La...
General Law
STATE CERTIFICATION

RE: University of California / U.S. Dept of Energy – Los Alamos National Laboratory
NPDES No. NM0028355

Department of Energy/University of California
Los Alamos National Laboratory
State Certification of Proposed NPDES Permit
NM0028355
March 28, 2000

FIGURE 4

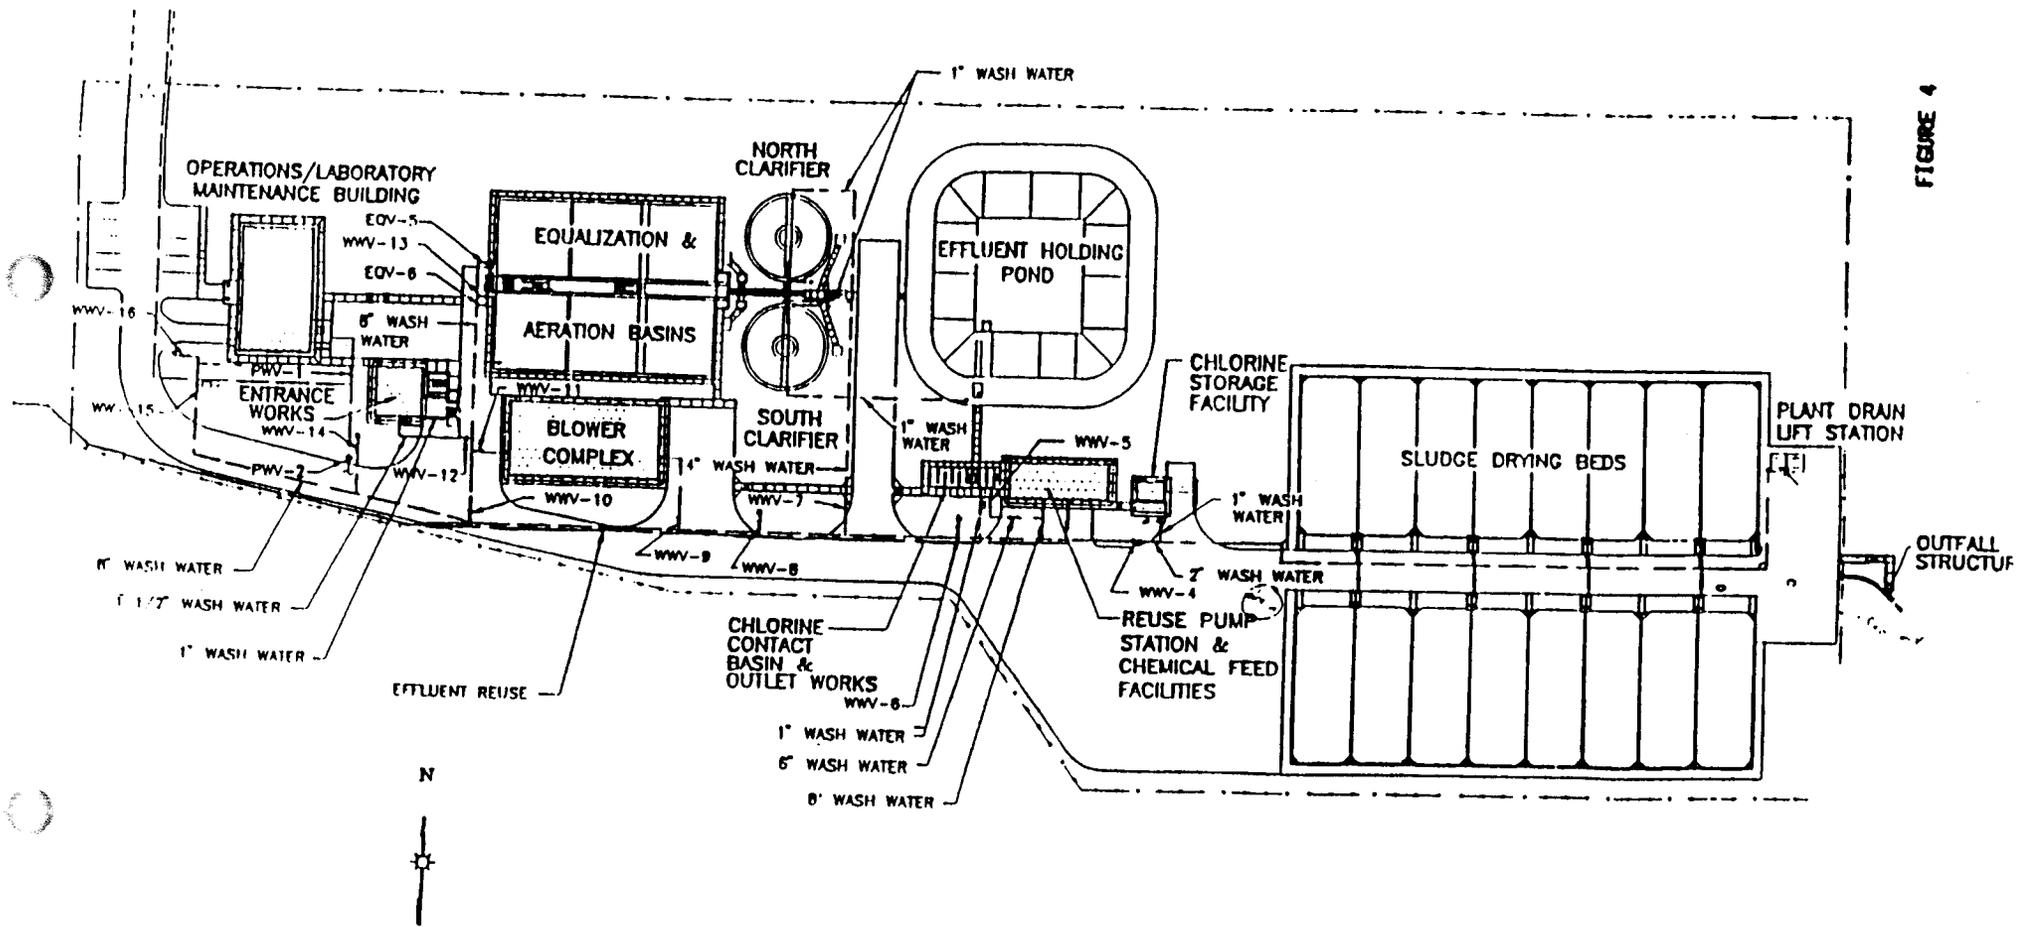
SWQB has reviewed diagrams of this facility previously provided by the permittee (copies attached). These diagrams were provided by SWQB to the EPA as part of the May 1997 NPDES Compliance Evaluation Inspection report (Attachment 3 Figs 4-6). SWQB believes the sampling location after the Parshall Flume (identified by LANL as 13S(a) in Appendix F of the May 1988 Permit Reapplication) is not adequate to properly characterize discharges from this facility to the environment. Samples and flow measurements taken after the Parshall Flume (located prior to the reuse line, holding pond and outfall to Canada del Buey) are not representative of the volume and nature of discharges for the following reasons:

4) volume measurements at the Parshall Flume may also be inaccurate due to possible improper installation of the flume. In review of the schematic diagrams it was noted that effluent must pass through two 90-degree turns immediately before entering the throat of the flume. According to the *U.S. Dept. of Interior, Bureau of Reclamation - Water Measurement Manual - 1981 reprint* regarding approach conditions for Parshall Flumes it states on page 52, in part: "...Parshall Flumes should not be placed at right angle to flowing streams...."

FIGURE 5

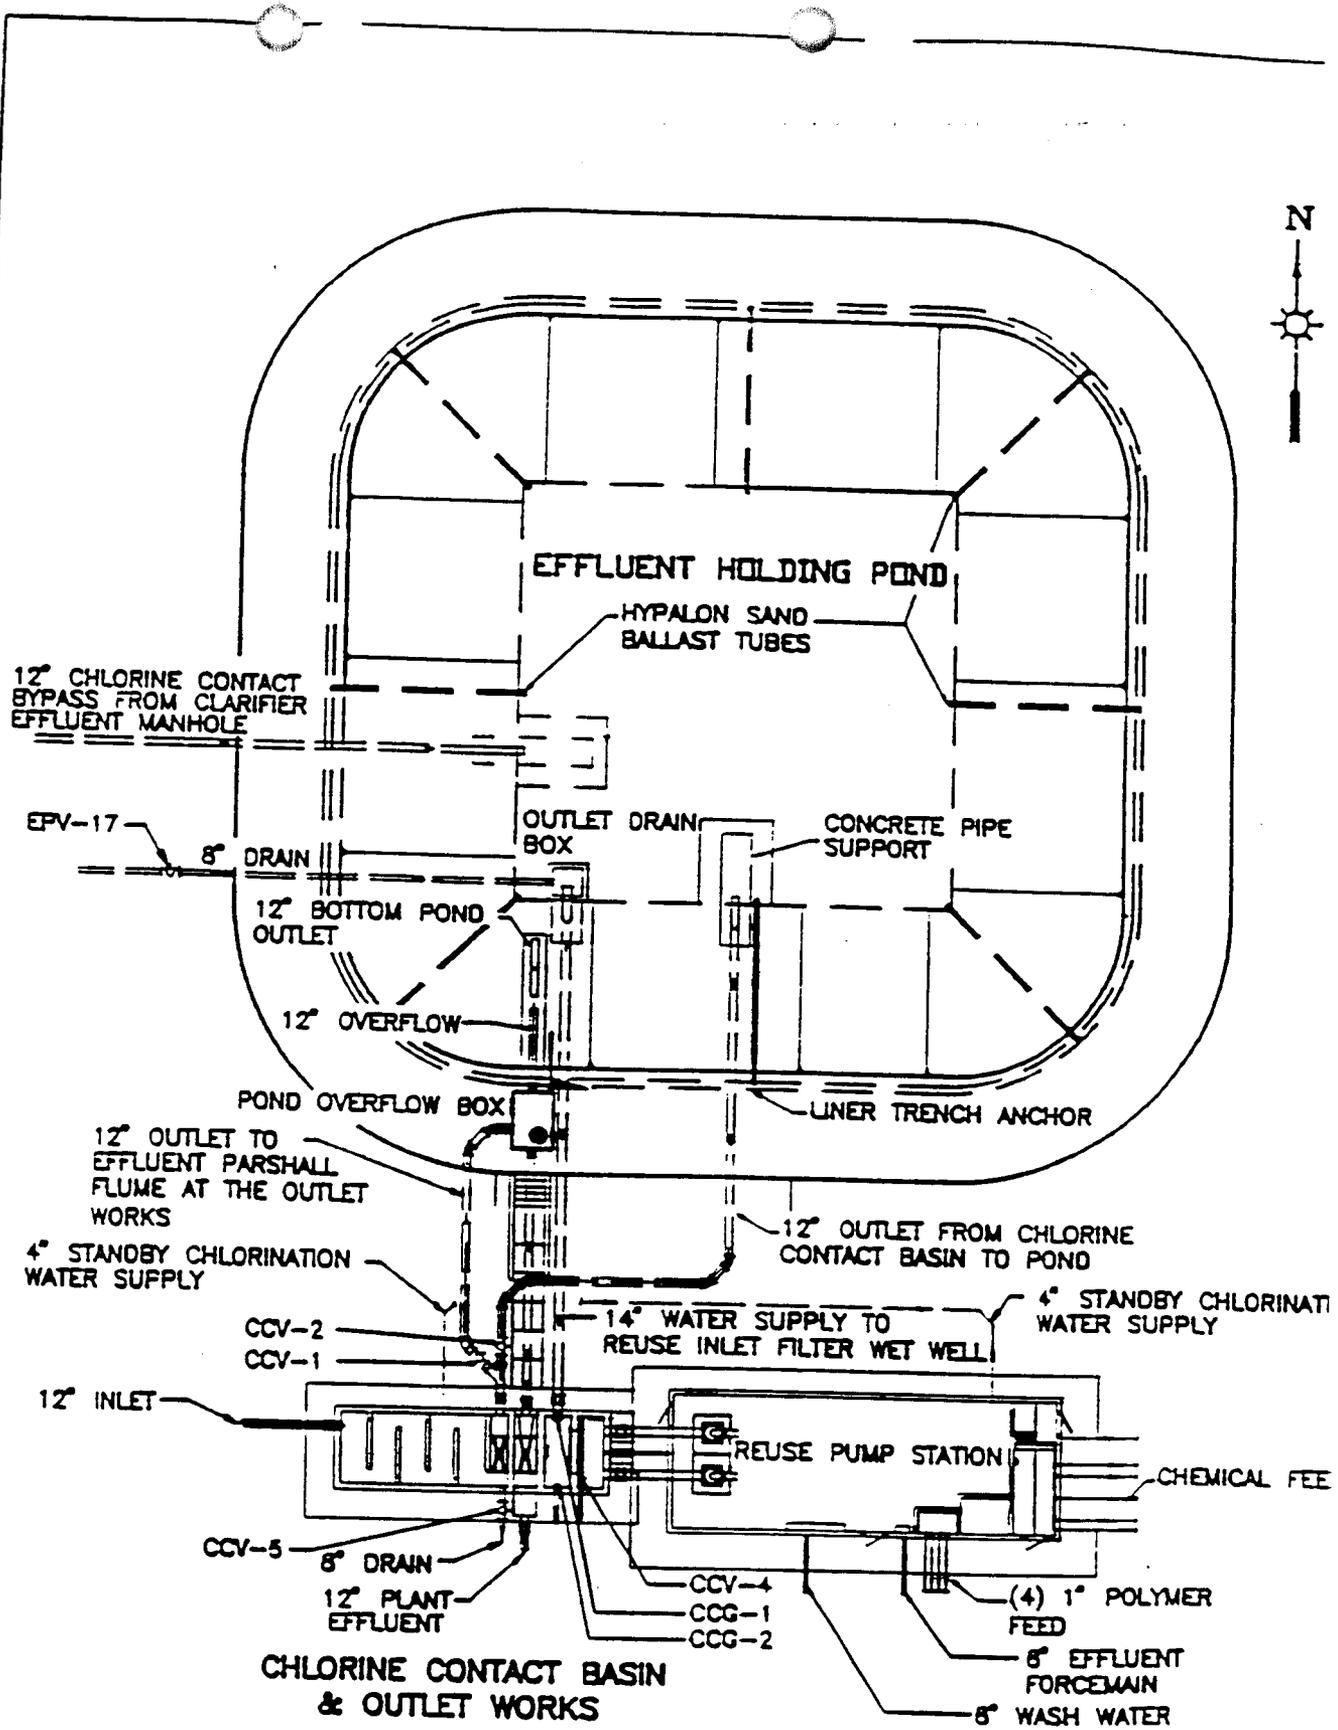
1) quality measurements taken immediately after the Parshall Flume may not be representative of discharges through 13S(b) because the effluent holding pond has inlet sources other than effluent coming through the

flume (e.g., fig. 5 shows a "12-inch Chlorine Contact bypass from Clarified Effluent Manhole" line) leading directly from the clarifier to the pond and plumbing exists that would allow contents of the pond to discharge to Canada del Buey through 13S(b). Additionally, LANL representatives have, when questioned about the presence of water and "greasy appearing bathtub rings" in the 13S(b) sump vis-à-vis their reports that no effluent has ever discharged through the outfall, verbally responded that the source of the water was storm water runoff. This location is downhill of the sludge drying beds and most of the wastewater treatment units, therefore it is feasible that storm water runoff could entrain contaminants from this area resulting from spills, overflows, or the normal working of this area. Such entrained contaminants (e.g., sludge) would be discharged but not measured if the only sampling point is after the Parshall Flume;

3) volume measurements taken at this location (i.e., at the Parshall Flume² between the chlorine contact chamber and the outlet to the reuse line or holding pond) do not discriminate quantities of effluent discharged directly to the reuse line and subsequently to other outfalls in other canyons after reuse, from quantities discharged directly to Canada de Buey (13S(b)), or into the adjacent holding pond for later discharge to either the reuse line or 13S(b). Further, inflow to the effluent holding pond received through the above mentioned "12-inch Chlorine Contact bypass from Clarified Effluent Manhole" line would also be unmeasured.

1) retain the proposed requirement to continuously monitor flow at the Parshall Flume (if the flume is deemed accurate) and monitor effluent

quality discharged to the holding pond or reuse system after the Parshall Flume. Report all data as outfall 13S(a); and

2) add required daily inspection of the discharge point identified by LANL as 13S(b) at the outfall to Canada del Buey, and if any discharge occurs, require manual measurement (e.g., staff gage for volume and grab samples) and separate reporting of the data on a Discharge Monitoring Report as outfall 13S(b).
